PROJECT: Skye Canyon Park Drive (Prev. Indian Hills Park)

CITY OF LAS VEGAS			DATE:
INTER-OFFICE MEMORANDUM			April 3, 2017
TO: Land Development Services Department of Building & Safety			FROM: Jennifer Shinn  Flood Control Engr. Associate Department of Public Works
SUBJECT: Drainage Study for: Skye Canyon Park Drive (Previously Indian Hills Park)			COPIES TO: Slater-Hanifan
Cross Streets:	Skye Canyon Park Drive & Iron Mountain		Ninety-Five Management, LLC
File Number:	F:\Depot\DSMemos\DS4951B.doc		Bart Anderson, P.E., DevCo
Parcel Number:	125-07-501-004		Fred Solis, Planning
Zoning Action:	VAR-55892		
FEMA Flood Zone	YES	NO X	
Proposed Storm Drain	YES	NO X

**TECHNICAL DRAINAGE STUDY
UPDATE ADDENDUM
Skye Canyon Park Drive**

**Subject: Addendum to the Technical Drainage Study Update for Skye Canyon Park Drive
(Previously Indian Hills Park; DS 4951)**

ULTIMATE CONDITIONS DRAINAGE EXHIBIT

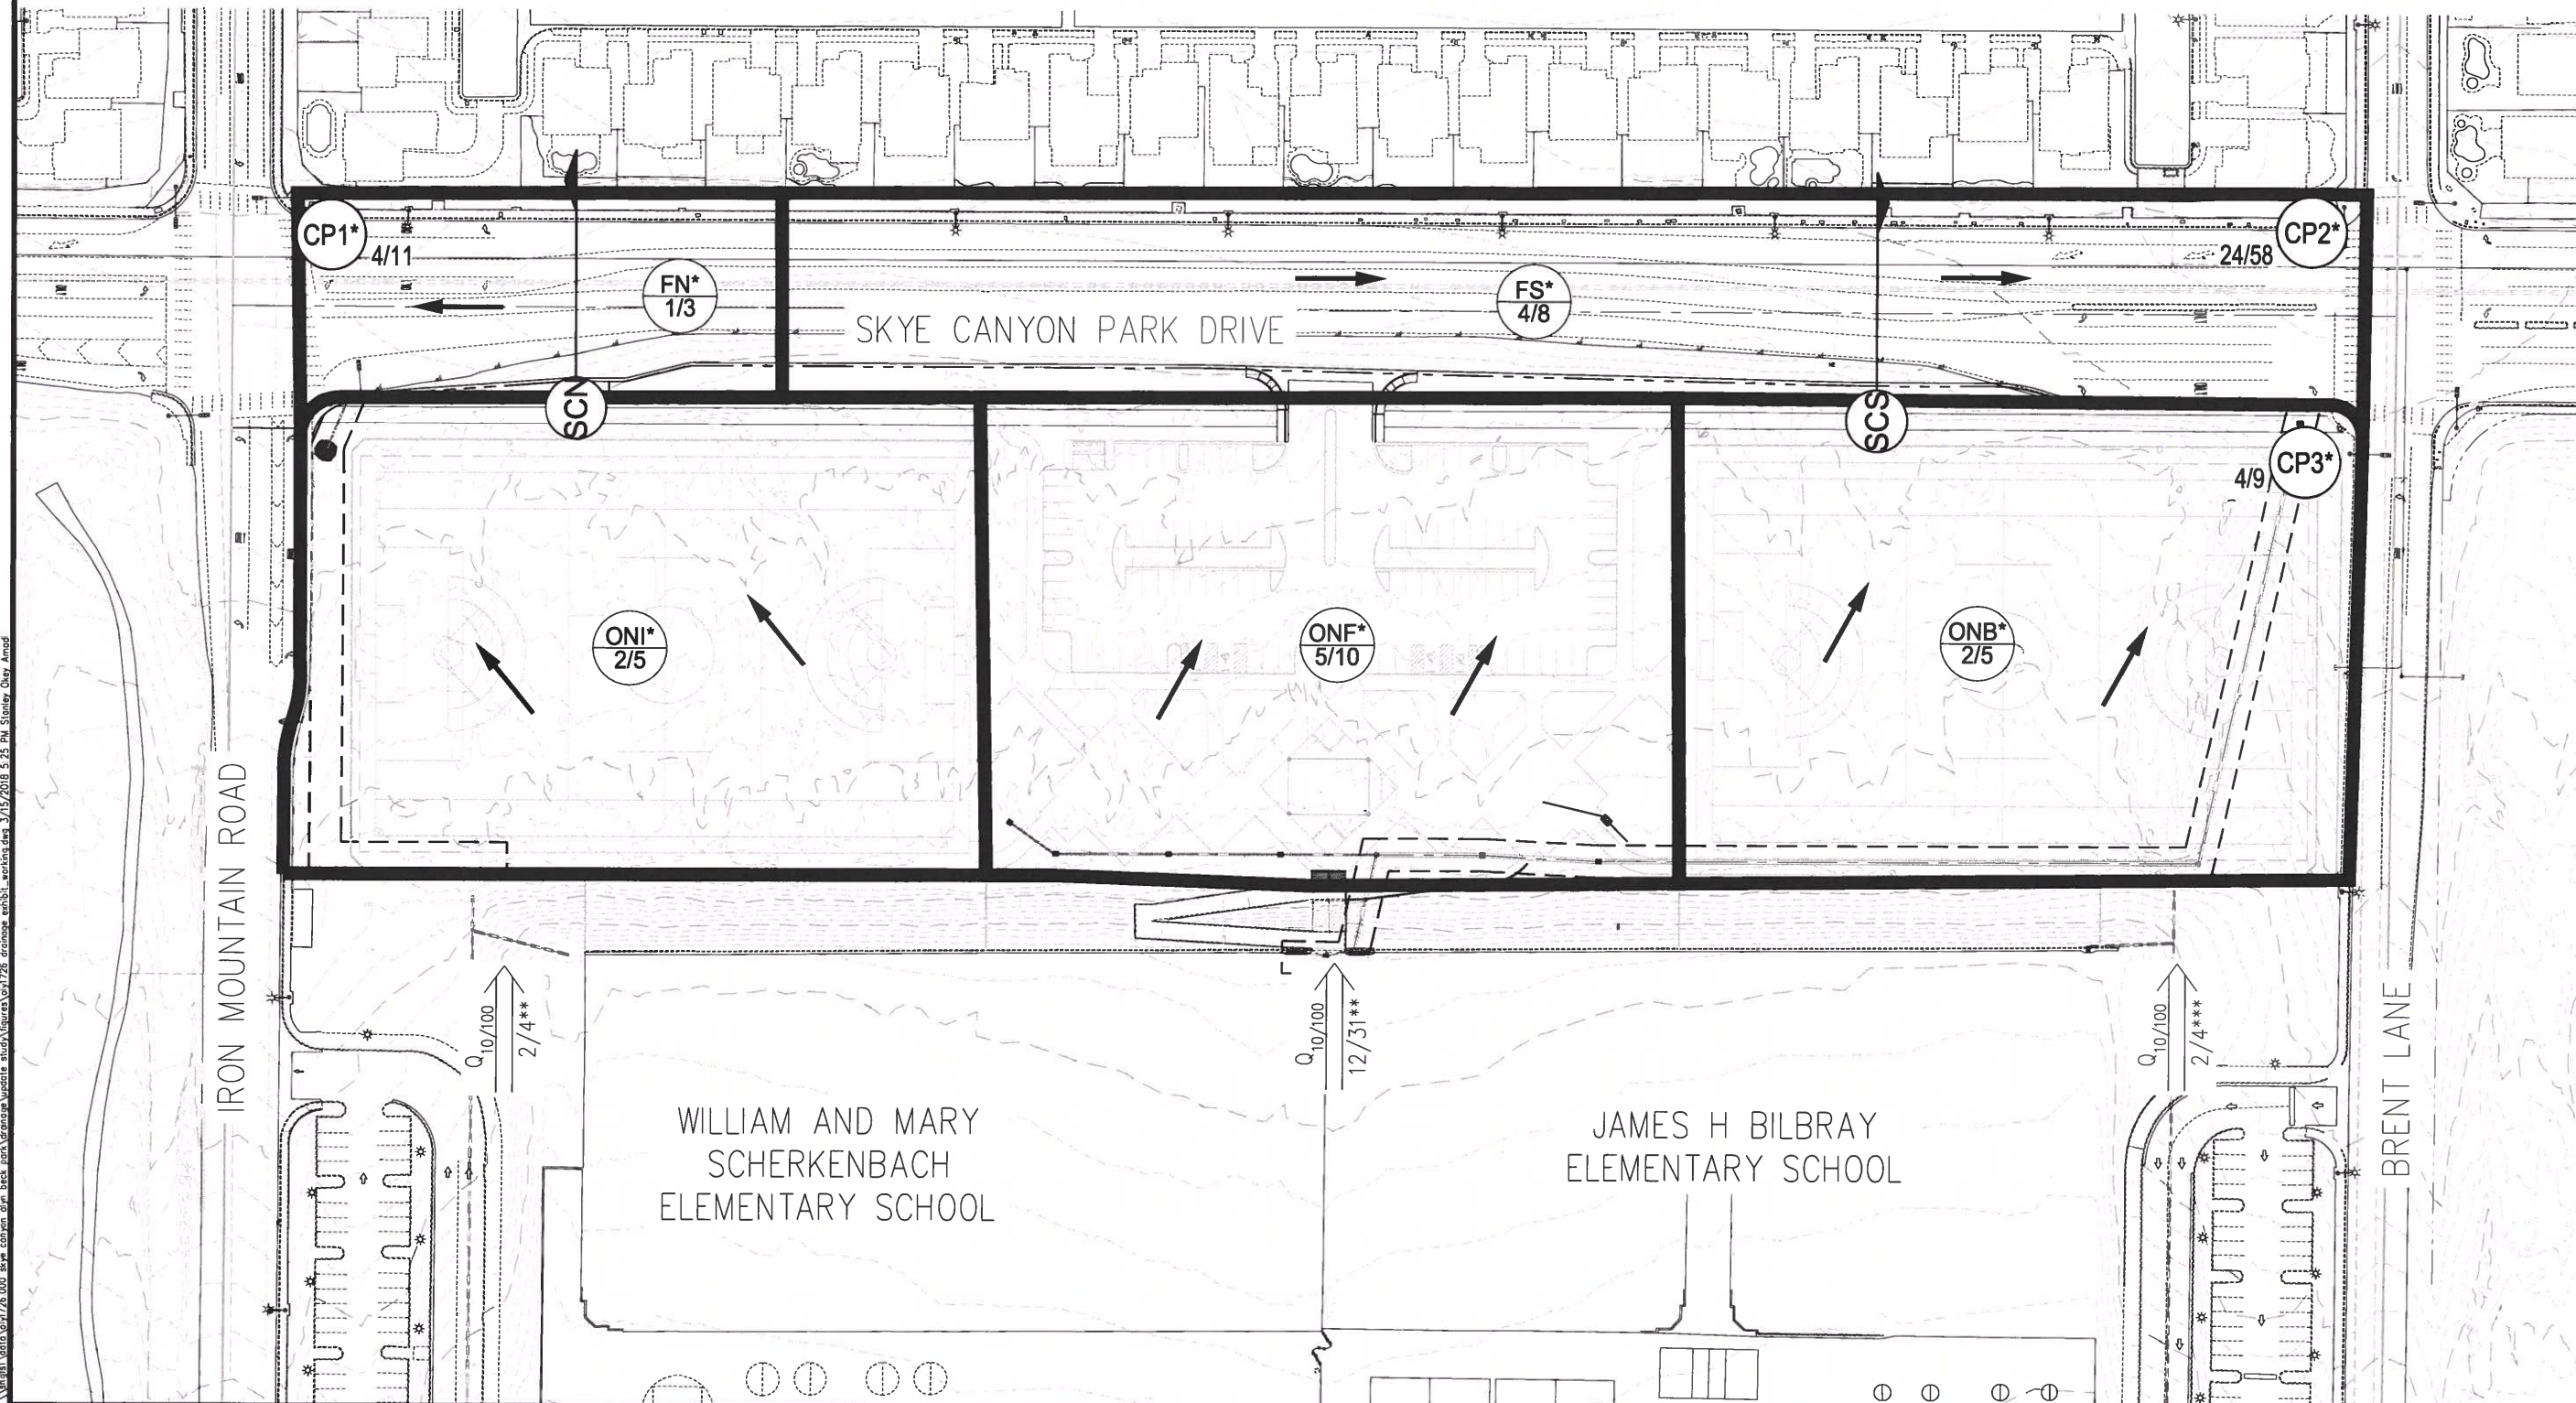
4. **Comment:** *It appears from the drainage basin map that the flows that impact Skye Canyon Park Drive North from the west will be contained on the west side of Skye Canyon Park Drive. Revise the FlowMaster models to reflect this condition.*

5. **Comment:** *Provide calculations to demonstrate the dry lane criteria is satisfied.*

6. **Comment:** *Label the Q10/Q100 flow rates for CP3* on Exhibit D Ultimate Conditions Drainage Exhibit.*

- It appears from the drainage basin map that the flows that impact Skye Canyon Park Drive North from the west will be contained on the west side of Skye Canyon Park Drive. Revise the FlowMaster models to reflect this condition.

5. Provide calculations to demonstrate the dry lane criteria is satisfied.
6. Label the Q10/Q100 flow rates for CP3* on Exhibit D Ultimate Conditions Drainage Exhibit.

Response: Acknowledged. Section SCN for Skye Canyon Park Drive has been revised to model a half street section. The Street Cross Section Hydraulic summary table on Exhibit D has been updated to reflect the revised calculations. Please refer to the appendix for the revised calculations and exhibit.

Response: Calculations provided with the previous submittal indicate that the 10-year storm event dry lane criteria is satisfied. The revised calculation for Section SCN also indicates that the dry lane criteria is satisfied. The Street Cross Section Hydraulic summary table on Exhibit D has been updated to include a column for the dry lane width.

Response: The Q10/Q100 for CP3 has been labeled on Exhibit D.
